MEETING AGENDA

CITY PLAN COMMISSION Wednesday, February 23, 2022 Work Session 12:30 p.m. Public Hearing: 1:30 p.m.

PP-21-100 Eagles Crossing, Lots1-2, 3X, 4-31, Block 1; Lots 1-44, Block 2; Lots 1-44, Block 3; Lots 1-44, Block 4; Lots 1-9, Block 5; Lots 1-3, 4X, 5-27, 37X, Block 6 (Waiver Request/Conditional Approval): 195 Single-Family Detached Residential Lots, 1 Multi-Family Lot, 1 Gas Well Pad Lot and 5 Private HOA Open Space Lots. Council District 6.

Case: PP-21-100	Remarks Due:
Submitted: 12/8/2021	ZC Hearing:
	Case Status: In Revi
Title: Eagles Crossing

Copyright 2021

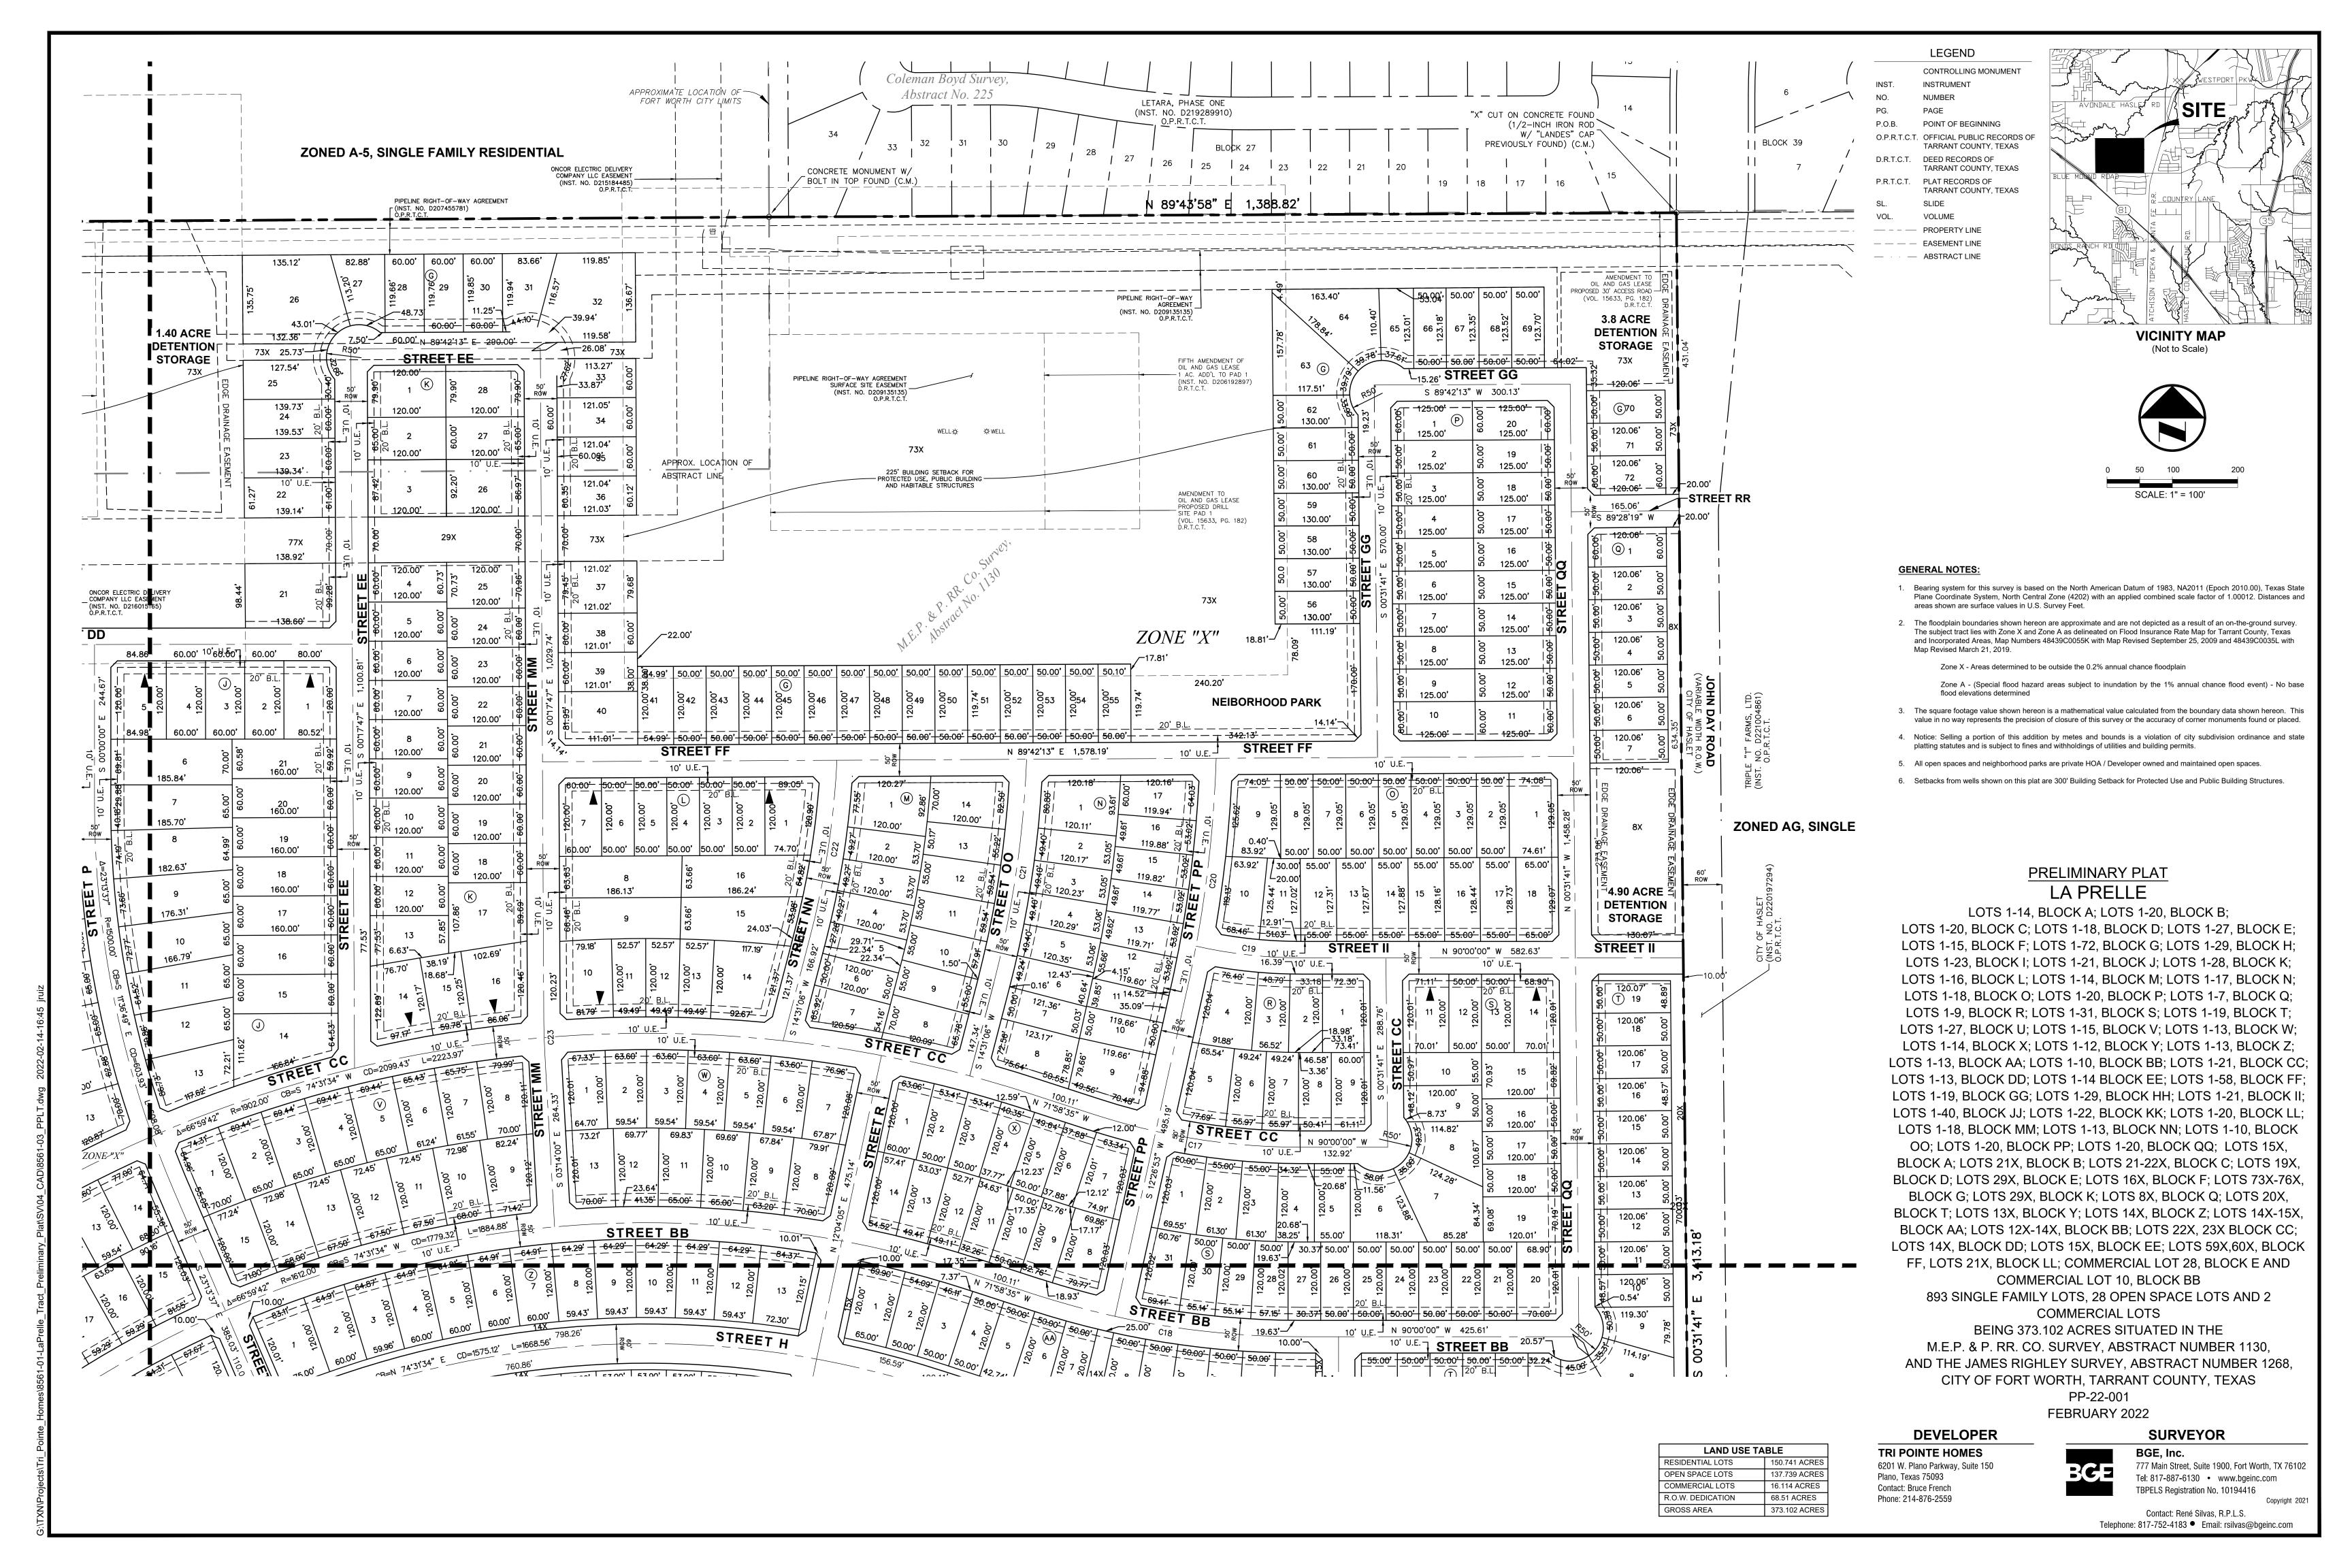
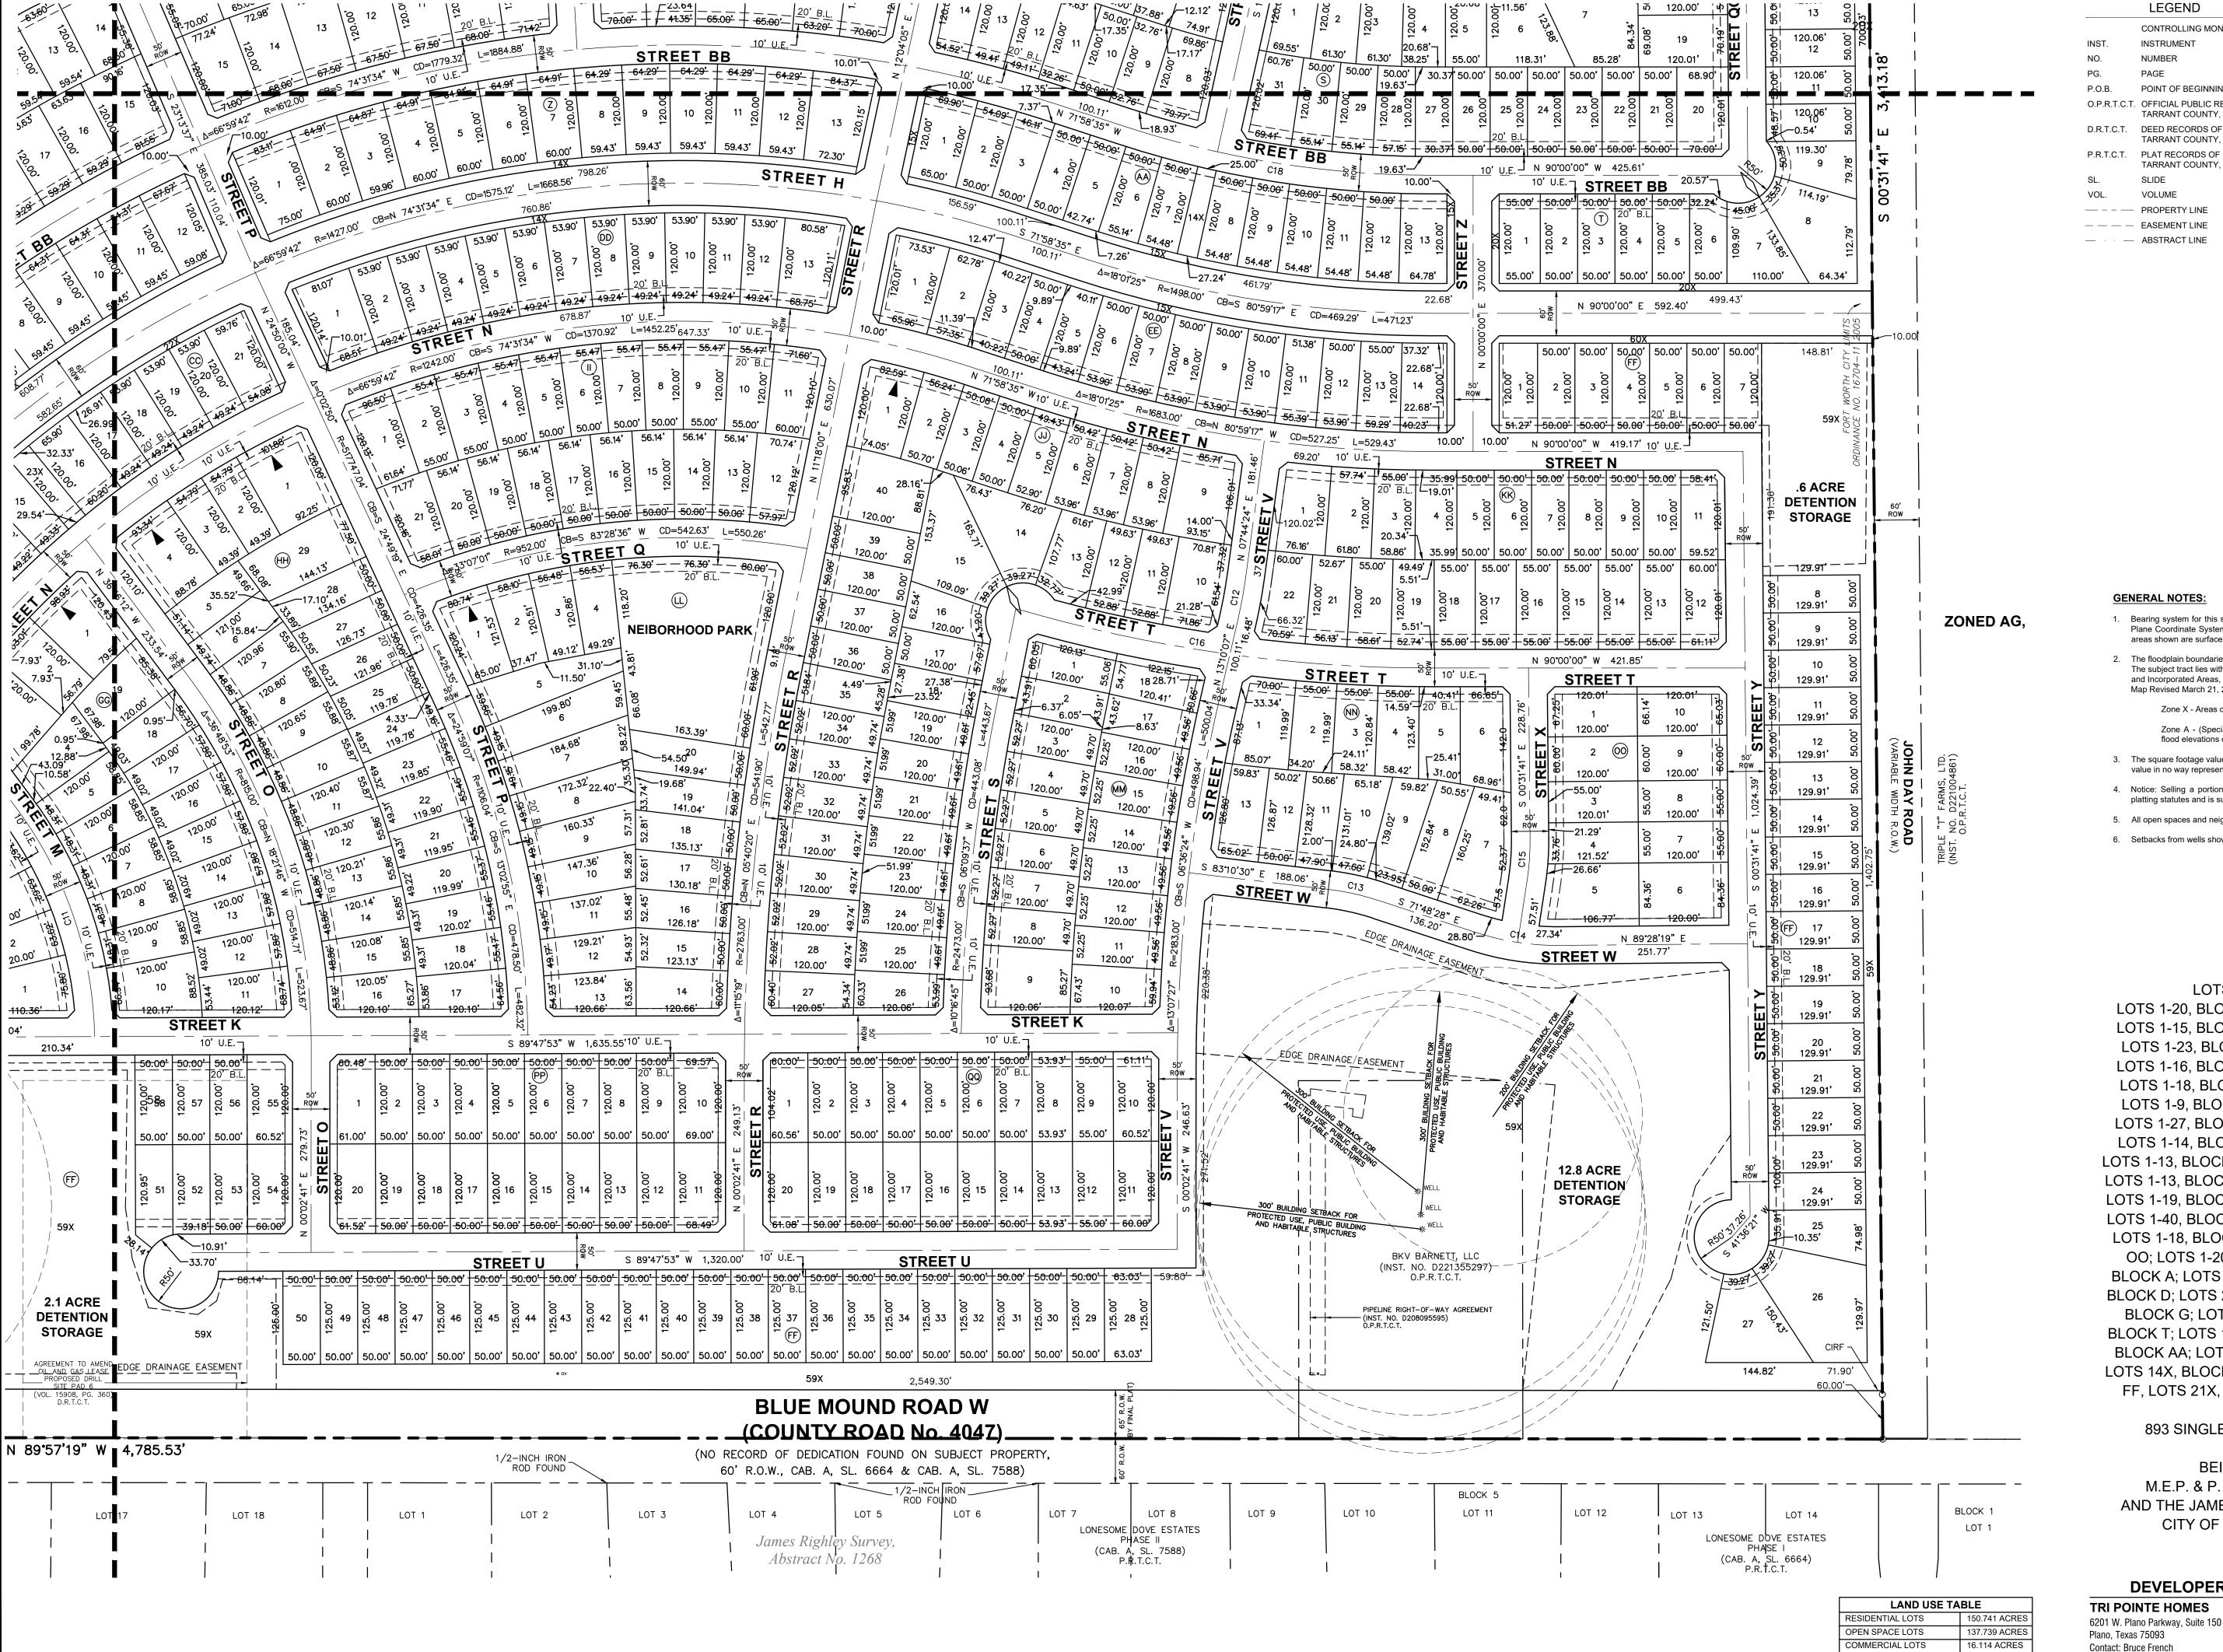
Need to show and label gas well and lift compressor setbacks: the setbacks for the gas well sites on Blue Mound Rd W need to be measured from the well bores: 300' for protected uses and public buildings and 200' for habitable structures - the lift compressor setback is measured from the center of the lift compressor or spotted location: 200' for protected uses, public buildings, and habitable structures.

Correct Blue Mound Road to Blue Mound Road W

Provide copy of special warranty deed to TPHMI DFW 4047 LLC to document ownership of the three tracts combined for the 373.102 acres preliminary plat.

MTP roadways Wagley Robertson- Neighborhood Connector [NCO-L2-T0-NTMS-P0-BOP (110)] 110-foot ROW (Proposed Street I) and John Day - Neighborhood Connector [NCO-L2-T0-NTMS-P0-BOP (110)] 1110-foot ROW. Verify location, dedication requirement, specifics with TPW Transportation.

Subdivision Ordinance, Section 31-102(b)(2) Interconnectivity of Neighborhoods. Fragmented street systems impede emergency access and increase the number and length of individual trips. New residential subdivisions shall be designed to coordinate with existing, proposed and anticipated streets. Local and collector streets shall be extended to the tract boundary to provide future connection with adjoining un-platted lands. Street extensions are required to the unplatted tracts to the north (Nance Tract) and west. Stubout not provided through Open space Lot 34X. A project redesign or CPC approval of waiver request is required.

- 1. (Records Management and Real Property) Variable ROW Show the full ROW widths for all existing streets. For streets having variable ROW, call out the ROW as "Variable" and give "Range" of the ROW. Show the right-of-way width for John Day Road. CLEARED 02/10/2022 AB.
- 2. Label Plat Show Case Number on the plat. (But not as part of title block). CLEARED 02/10/2022 AB.
- 3. Plat shows that John Day Road is located in Haslet. However Haslet GIS map states differently. Confirm location of John Day Road

- Contact: sds@fortworthtexas.gov
- 1. Show connecting line callout out for proposed Floodplain Easement to both sides of Floodplain with a centered label & reference study for Floodplain Easement.
- 2. Show connecting line callout to both sides of the FEMA Effective Floodplain per the FEMA NFHL Map and label the effective FIRM Panel and Effective Date on plat face.
- 3. Label all detention pond drainage easements seen on Lot 8X, 34X, 59X, & 76X and show storage in ac-ft. Reference Sheet 36, Preliminary Storm Layout in DS-21-0144.
- 4. Show all proposed storm outfall drainage easements per Sheet 19 D.A.M. & Sheet 36, Preliminary Storm Layout in DS-21-0144.
- 5. Show Drainage Easements for Blue Mound Rd as seen Sheet 36, Preliminary Storm Layout in DS-21-0144.

3- Provide adequate water/sewer exclusive easements to match city accepted construction plans per the Installation Policy and Design Criteria for Water, Wastewater, and Reclaimed Water Infrastructure May 2019. Offsite easements and or easements by separate instrument need to have recording information shown on plat before hold can be cleared. Plat will be reconciled with reviewed and accepted plans to make sure all easement are correct before hold can be cleared.
